SAFETY RECALL NOTICE

NHTSA Campaign Number: **13E-024**

Re: Recall of certain master cylinders used on Bosch Hydro-Max® (Identified in table below)

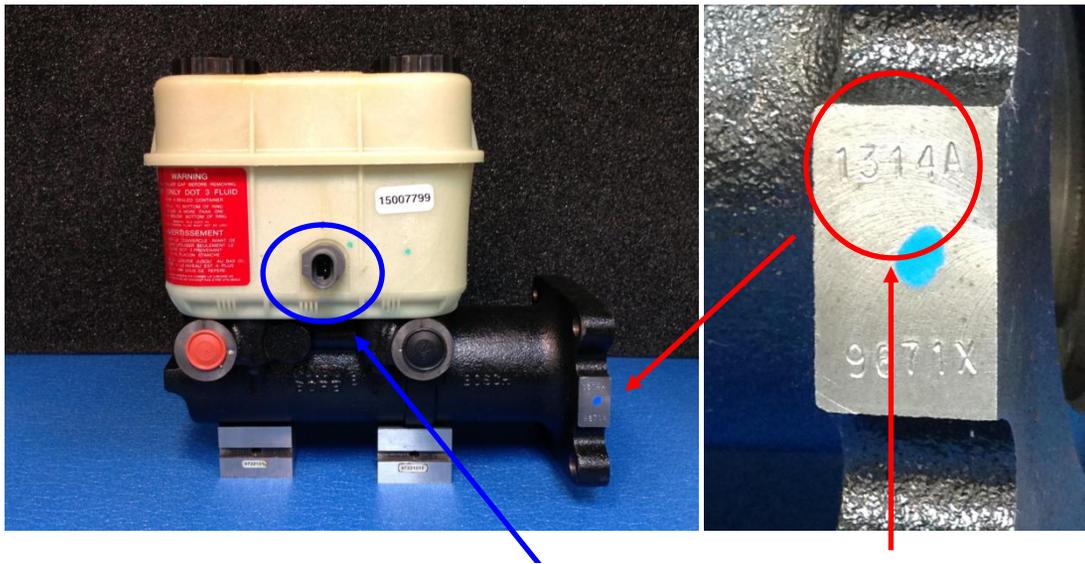
This recall involves brake master cylinders used on Hydro-Max® boosters with the part numbers identified in the table below that were manufactured July 1, 2011 through April 12, 2012. The date code is stamped on the upper left side of the master cylinder mounting flange (refer to photo). Only date codes 1182 through 2103 are included in the recall.

Only products with datecodes 1182 through 2103 as marked on the upper left side of the master cylinder mounting flange are subject to this recall. For purposes of identification, the letter that follows the 4 numbers is ignored.

The subject master cylinders manufactured by Bosch from July 1, 2011 through April 12, 2012 have a condition where the brake fluid level indicator may not properly detect a low brake fluid situation if the fluid level indicator switch moves outward in the assembly. If the low brake fluid level is caused by an external leak resulting in the escape of fluid from the brake system, it can result in increased pedal travel. If this condition is not addressed it can result in a reduction of available braking force which could increase the required stopping distance and increase the risk of a crash.

As a precaution, with your vehicle parked on a level surface and the engine off, locate the FLI switch (refer to photo) on the master cylinder reservoir and push it inward as far as possible. You should also check that the brake fluid level is full. Refer to your vehicle owner's manual or the label on the master cylinder reservoir for further reference.

Contact your dealer or installer as soon as possible and arrange an appointment to have the master cylinder serviced. The dealer or installer will check the manufacturing date of the master cylinder and if it's included in the recall, will remove the gray colored FLI switch and replace it with a redesigned brown colored FLI switch. Recall kits including the new brown FLI switch and installation instructions will be available on April 24, 2013. When scheduling an appointment please verify that the dealer or installer already has a recall kit on hand. If they do not have the kit or are unaware of this recall, please call the Bosch Technical Support and Warranty Hotline at 1 (855) 426-7247 and request a recall kit.
